NMOCD  
ArtesiaUNITED STATES  
DEPARTMENT OF THE INTERIOR  
BUREAU OF LAND MANAGEMENTFORM APPROVED  
OMB NO. 1004-0137  
Expires: January 31, 2018**SUNDRY NOTICES AND REPORTS ON WELLS**  
*Do not use this form for proposals to drill or to re-enter an abandoned well. Use form 3160-3 (APD) for such proposals.*5. Lease Serial No.  
NMLC070337

8. Well Name and No.  
DRICKEY QUEEN SAND UNIT 0359. API Well No.  
30-005-0103510. Field and Pool or Exploratory Area  
CAPROCK-QUEEN11. County or Parish, State  
CHAVES COUNTY COUNTY, NM**SUBMIT IN TRIPLICATE - Other instructions on page 2**

## Revisions to Operator-Submitted EC Data for Sundry Notice #433071

**Drickey Queen Sand Unit 35  
30-005-01035  
Remnant Oil Operating, LLC  
September 26, 2018  
Conditions of Approval**

## Proposed P&A Wellbore Diagram

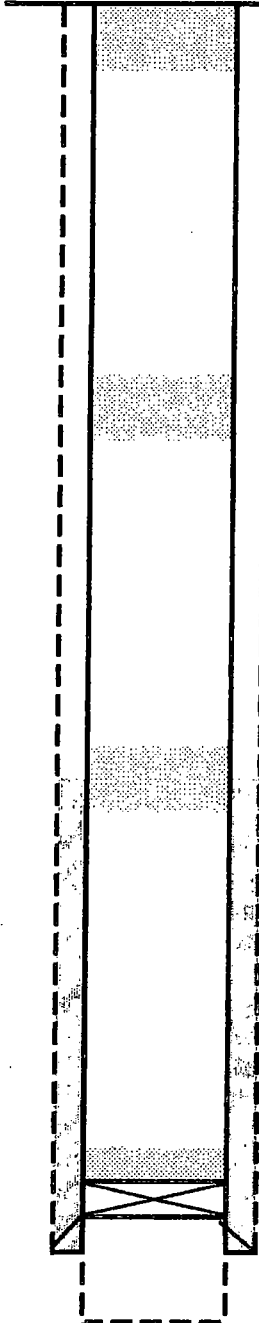
250' Perf!  
Cmt Plug from 150'-0'  
-- No Surface Casing was set -- The Sundry Notice dated 11-04-53 states that "No surface water has been encountered in offset wells, and permission was previously obtained to pull the surface pipe and cement around the top of the 5 1/2". Similar procedure will be followed on this well."

Cmt Plug from 1200'-1100' ✓

plug 1,400' - 1,250'

Calc'd TOC @ 2392'  
Cmt Plug from ~~2425'-2325'~~

2,392' - 1950'

Dump 25 sx cmt on top  
CIBP @ 2800'  
7" 20# @ 2875' w/100 sx  
Top of Queen @ 2884':  
Queen Open Hole: 2884' - 2893' (11-53)

TAG

- 1. Operator shall Tag TOC at 2800'.**
- 2. Operator shall perf and squeeze at 2,392' and balanced Class C cement plug from 2,392'-1,850' to seal the top of the Yates Formation and bottom of Salt Formation. WOC and TAG.**
- 3. Operator shall place a balanced Class C cement plug from 1,400'-1,250' to seal the top of the Salt Formation. WOC and TAG.**
- 4. Operator shall set a balanced Class C plug at 1200'-1100' as proposed.**
- 5. Operator shall perf and squeeze at 250' bringing cement to surface to ensure there is cement behind pipe.**
- 6. See Attached for general plugging stipulations.**
